Re:	Initial Submission Review	Blue Eagle Logistics Park - Master Plan
	Application Number:	DA-2375-00
	Case Numbers:	2024-7001-00

PLANNING DEPARTMENT COMMENTS

Sheet Number: PA-3
4 OF 7

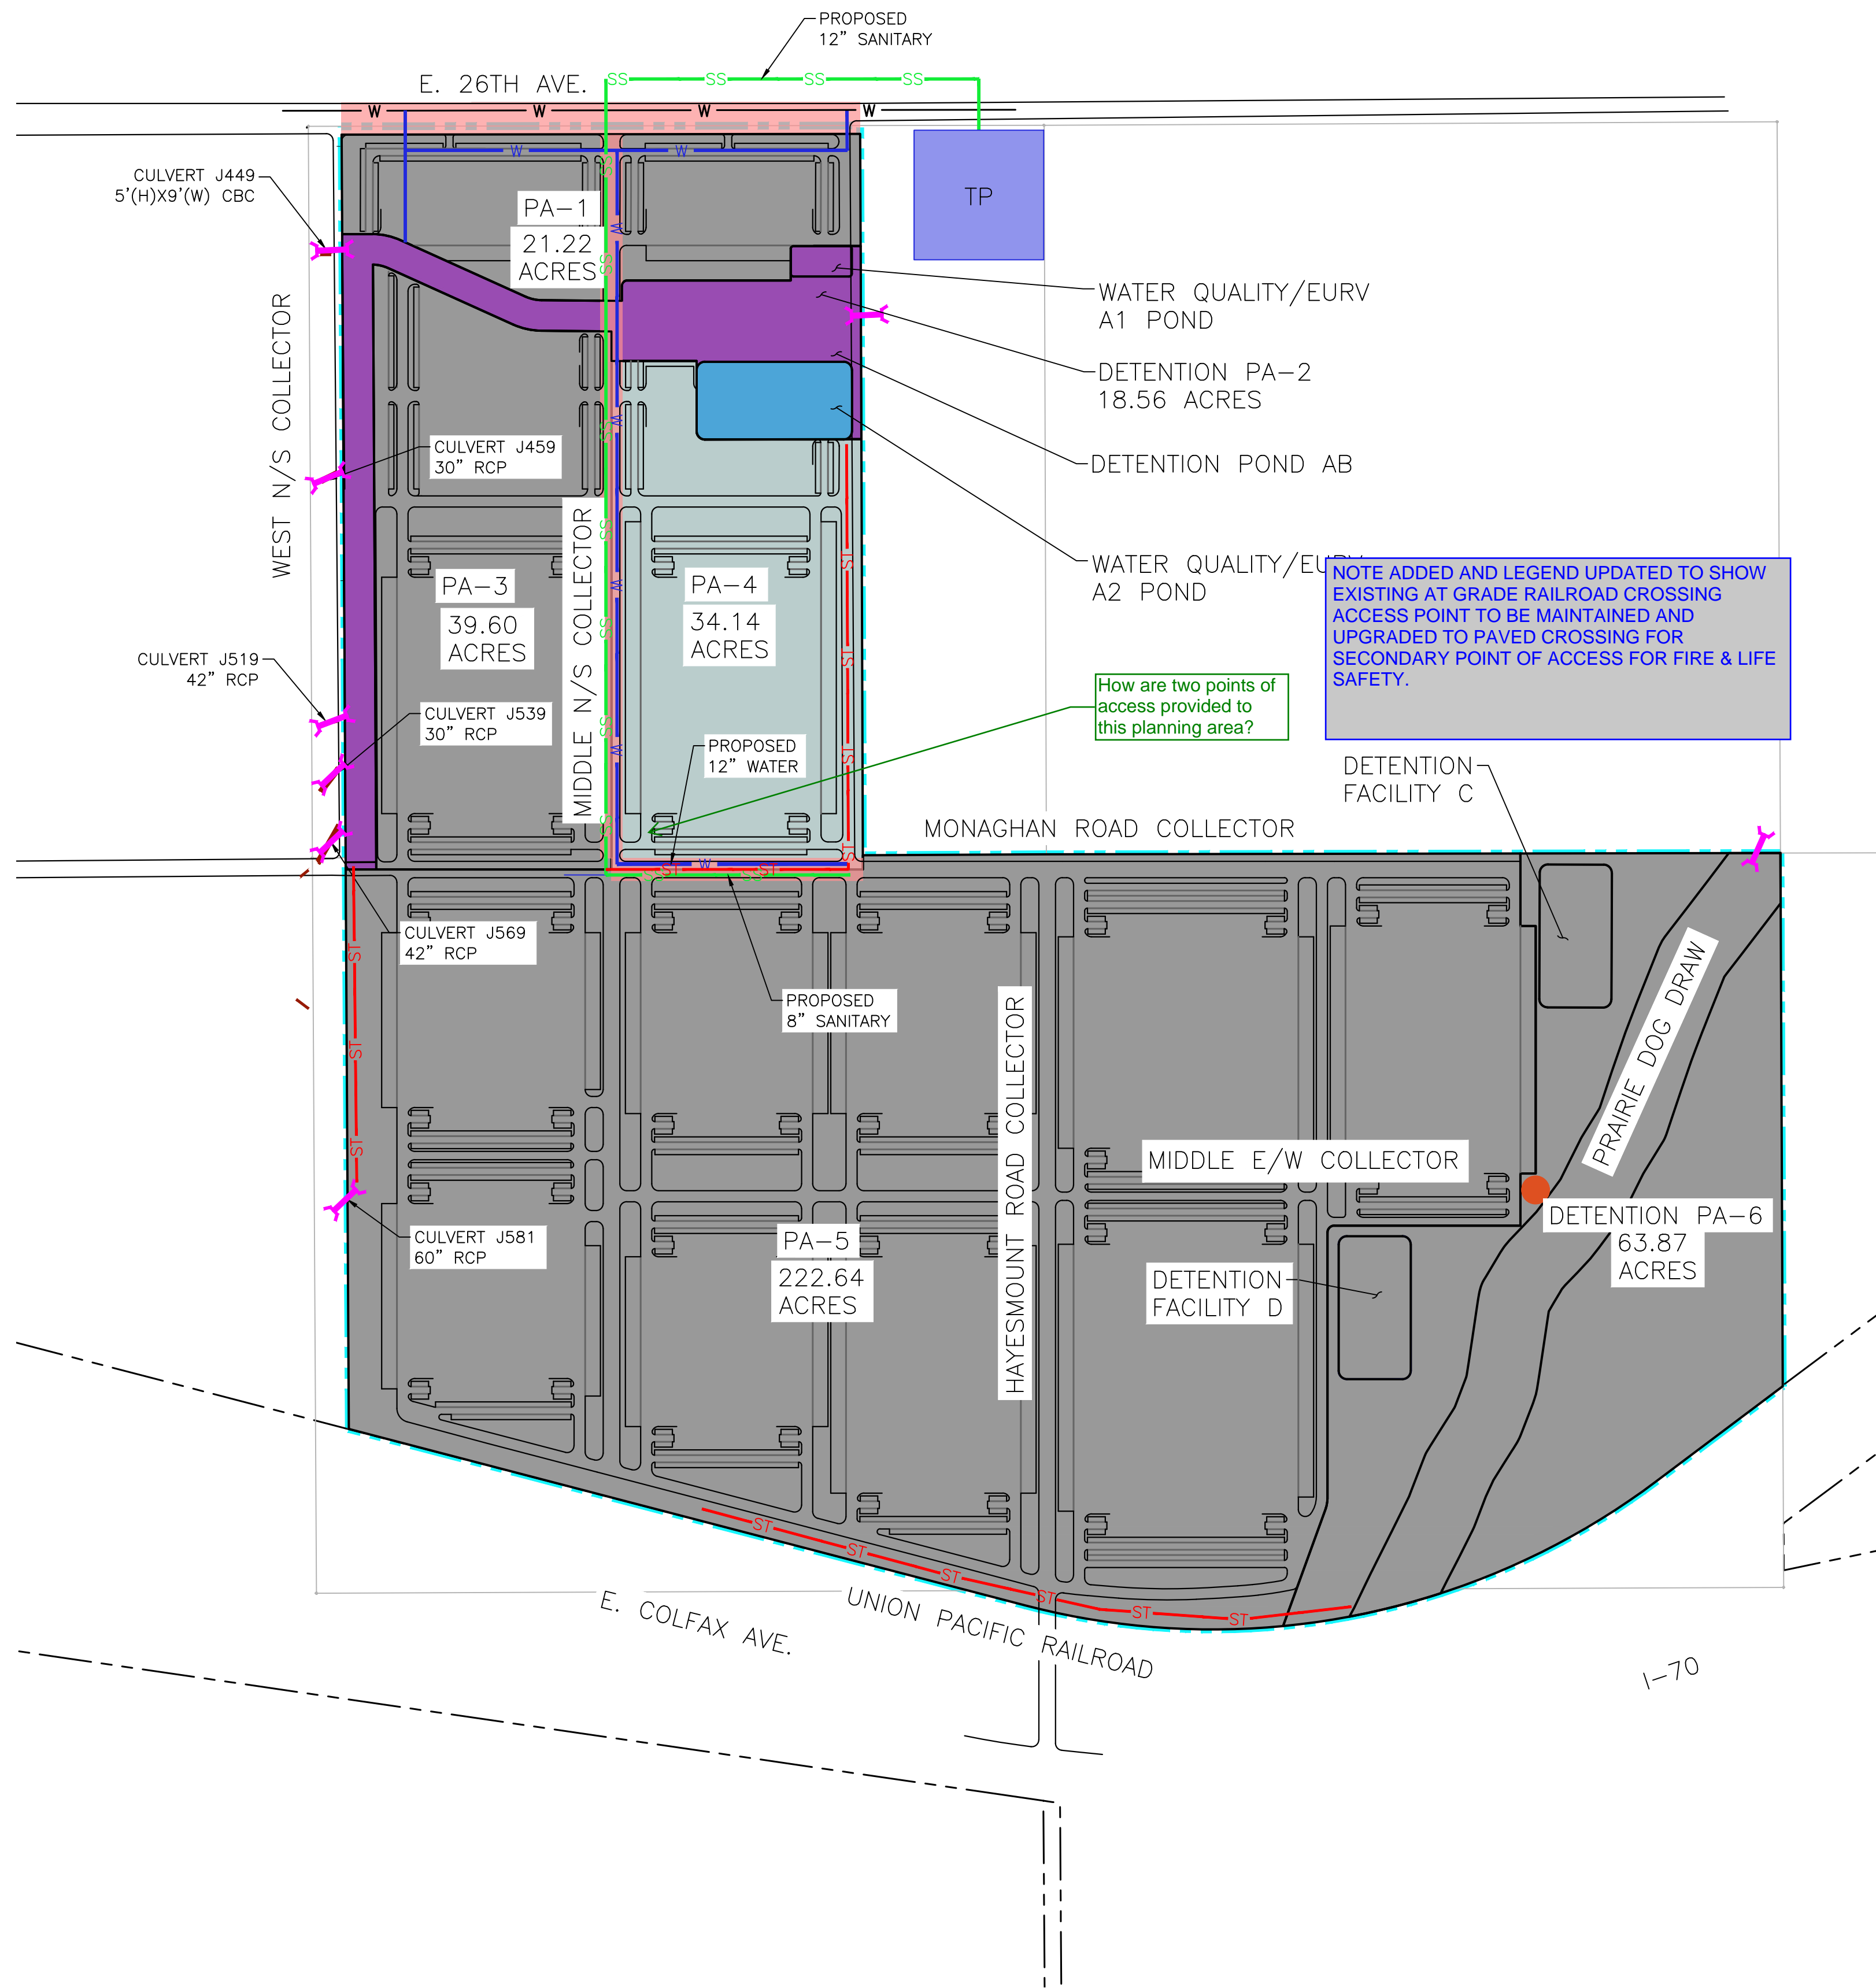
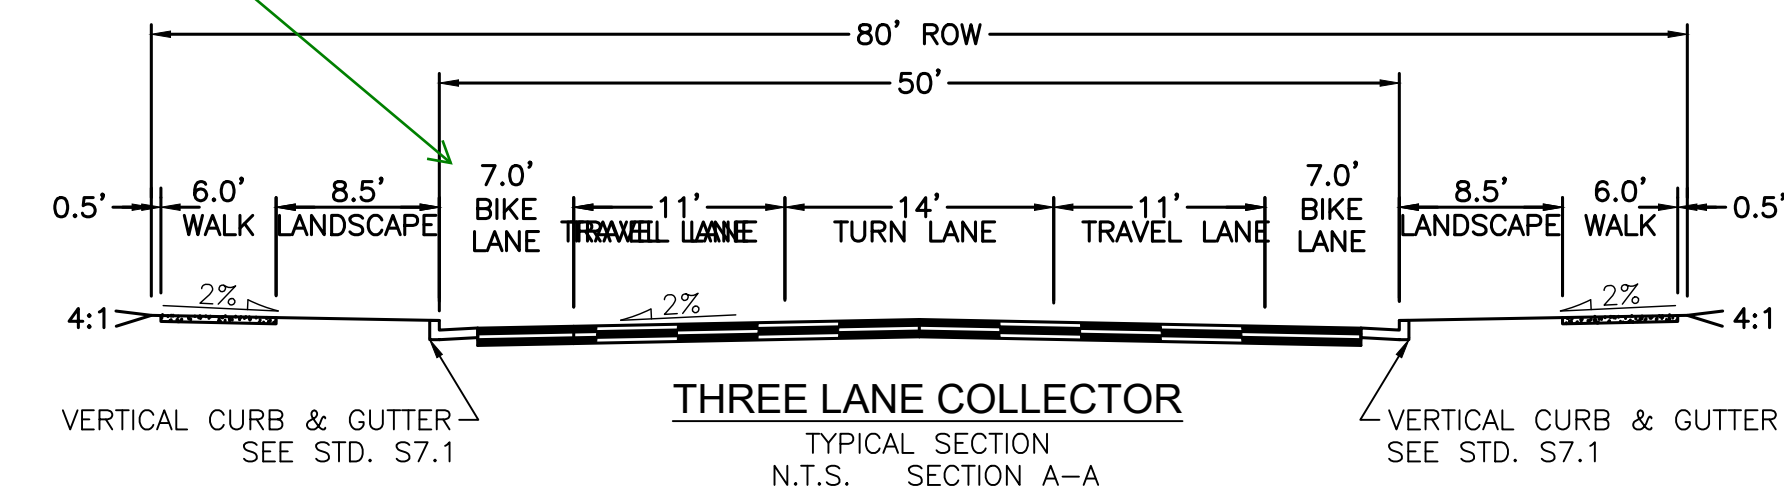
Which collector is proposed and where?

The narrative indicates that only half sections of the collectors are required for these planning areas. Please show that requirement on the proposed sections or revise the narrative to require full sections of the collectors. (typical all exhibits)

ROAD CROSS SECTION UPDATED
